**DEPARTMENT OF TRANSPORTATION**  
 DIVISION OF ENGINEERING SERVICES  
 Office of Structural Materials  
 Quality Assurance and Source Inspection

## QUALITY ASSURANCE -- NON-CONFORMANCE REPORT

**Report No:** NCR-000659

**Reference Description:** Noted deflection exceeding contract requirement on 5CW Longitudinal Diaphragm Side Stiffener

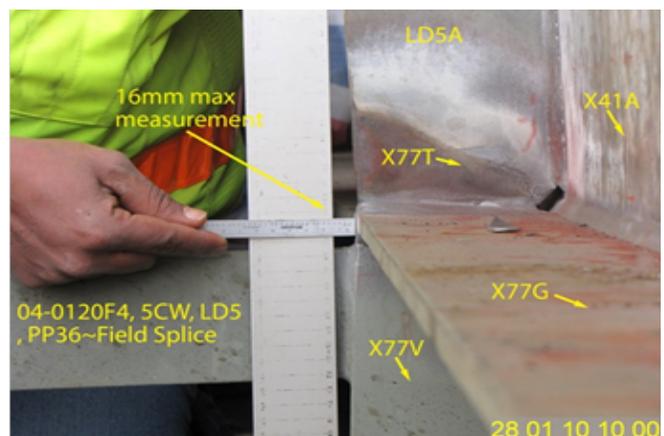
-Two (2) longitudinal diaphragm (LD) stiffeners were found to be out of tolerance over the length of both stiffeners measured vertically.

-16mm max deflection was measured with a straight edge in contact with the bottom of X77V and the top of X77T.

-Stiffeners X77T and X77V are attached to the intermediate stiffener X77G.

-The LD deflection was measured horizontally across the web and is 11mm in 4000mm on LD5A.

Propose a resolution for the identified non-conformance with revised procedures to prevent future occurrences and also provide documentation to show that the deflection has been properly corrected to meet contract requirements.

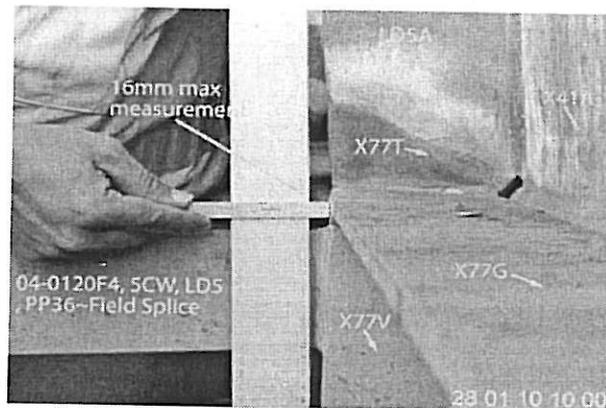
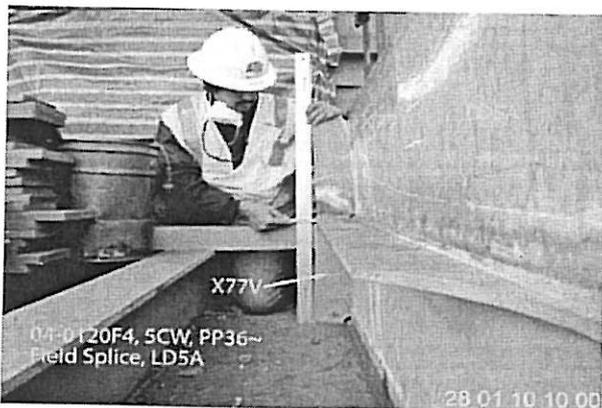
- During random Quality Assurance In-Process Visual inspection on segment 5CW, this Quality Assurance Inspector (QA) discovered the following issues:
- Two (2) longitudinal diaphragm (LD) stiffeners were found to be out of tolerance over the length of both stiffeners measured vertically.
- 16mm max deflection was measured with a straight edge in contact with the bottom of X77V and the top of X77T.
- Stiffeners X77T and X77V are attached to the intermediate stiffener X77G.
- The LD deflection was measured horizontally across the web and is 11mm in 4000mm on LD5A.
- The full length of LD5A is 4260mm.
- The field splice connecting LD5A is between 5CW to 6AW.
- These measurements were taken at Segment 5CW panel point (PP) 36 Counter Weight side.
- Segment 5CW is located outside in the OBG Trail Assembly area.

Allowable lateral variations between the centerline of the web and the centerline of the flange of built-up H or I members at contact surface shall not exceed 6mm (1/4).

项目名称 Project Name	美国海湾大桥 SFOBB	部件图号 Drawing No	LD5A	报告编号 Report No.	B-WR10718
合同号 Contract No.:	04-0120F4	部件名称 Items Name	纵桁 Longitudinal diaphragm	NDT报告编号 Report No.of NDT	NA
项目编号 Project No.:	ZP06-787

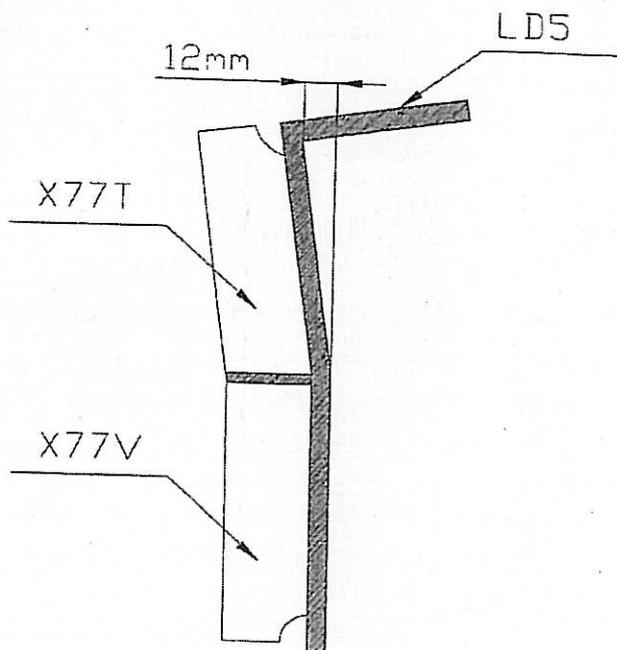
5CW配重块侧纵桁LD5A上的筋板X77T变形约12mm, 需要调整, 具体尺寸见下图:  
 The distortion was found at 5CW longitudinal diaphragm LD5A stiffener X77T face weight counter and needed to adjust, the detail size sees the following draft.

Weld distortion and fabricate error.

1. Remove the welds where the distortion is out of tolerance between X77TV and X77G by the way of gouging or Oxygen. Preheat according to the WPS prior to gouging.
2. Put in the heat straightening report to revise the distortion area to meet the require of the drawing.
3. Perform 100%VT inspection to the metal cutting area to ensure no defects exist ;
4. Preheat and weld according to the approved repair WPS;
5. Grind the weld flush to the adjacent weld or base metal.
6. Check the weld according to the shop drawings.

Note; during the process of heat straightening, fixture can be used to avoid deformation of LD to assure its match with relevant LD at the splice of girder.
